BRUCE H HAMILTON
Vice President
McGuire Nuclear Station

Subject: Duke Power Company LLC d/b/a
Duke Energy Carolinas, LLC
McGuire Nuclear Station, Units 1 and 2
Docket Nos. 50-369 and 50-370

Application to Revise Technical Specifications Regarding Control
Room Envelope Habitability in Accordance With TSTF-448,
Revision 3, Using the Consolidated Line Item Improvement Process

MARKED PAGES OF PROPOSED TECHNICAL SPECIFICATION CHANGES

SR 3.7.9.4

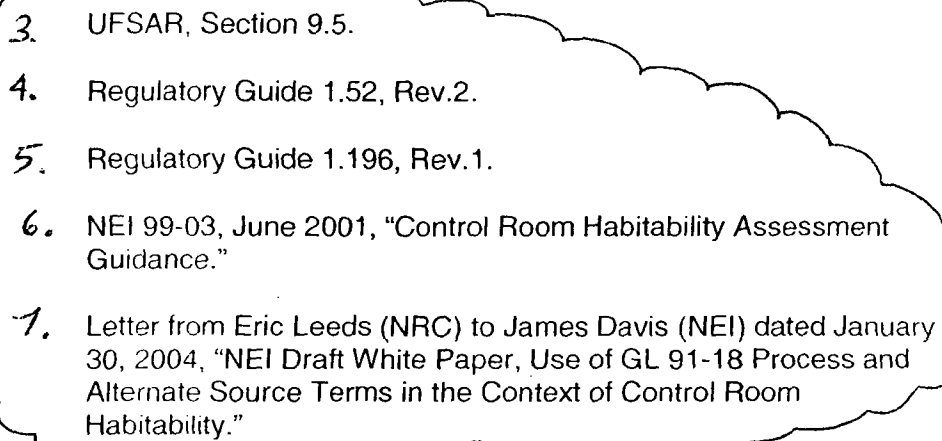
This SR verifies the integrity of the control room enclosure, and the assumed inleakage rates of the potentially contaminated air. The control room positive pressure, with respect to potentially contaminated adjacent areas, is periodically tested to verify proper functioning of the CRAVS. During the emergency mode of operation, the CRAVS is designed to pressurize the control room ≥ 0.125 inches water gauge positive pressure with respect to atmospheric pressure in order to prevent unfiltered inleakage. The CRAVS is designed to maintain this positive pressure with one train at a makeup flow rate of ≤ 2200 cfm. The Frequency of 18 months on a STAGGERED TEST BASIS is consistent with the guidance provided in NUREG-0800 (Ref. 5).

INSERT
7

INSERT 7: SR 3.7.9.4

This SR verifies the OPERABILITY of the CRE boundary by testing for unfiltered air leakage past the CRE boundary and into the CRE. The details of the testing are specified in the Control Room Envelope Habitability Program.

The CRE is considered habitable when the radiological dose to CRE occupants calculated in the licensing basis analyses of DBA consequences is no more than 5 rem whole body or its equivalent to any part of the body and the CRE occupants are protected from hazardous chemicals and smoke. This SR verifies that the unfiltered air leakage into the CRE is no greater than the flow rate assumed in the licensing basis analyses of DBA consequences. When unfiltered air leakage is greater than the assumed flow rate, Condition B must be entered. Required Action B.3 allows time to restore the CRE boundary to OPERABLE status provided mitigating actions can ensure that the CRE remains within the licensing basis habitability limits for the occupants following an accident. Compensatory measures are discussed in Regulatory Guide 1.196, Section C.2.7.3, (Ref. 5) which endorses, with exceptions, NEI 99-03, Section 8.4 and Appendix F (Ref. 6). These compensatory measures may also be used as mitigating actions as required by Required Action B.2. Temporary analytical methods may also be used as compensatory measures to restore OPERABILITY (Ref. 7). Options for restoring the CRE boundary to OPERABLE status include changing the

licensing basis DBA consequence analysis, repairing the CRE boundary, or a combination of these actions. Depending upon the nature of the problem and the corrective action, a full scope inleakage test may not be necessary to establish that the CRE boundary has been restored to OPERABLE status.
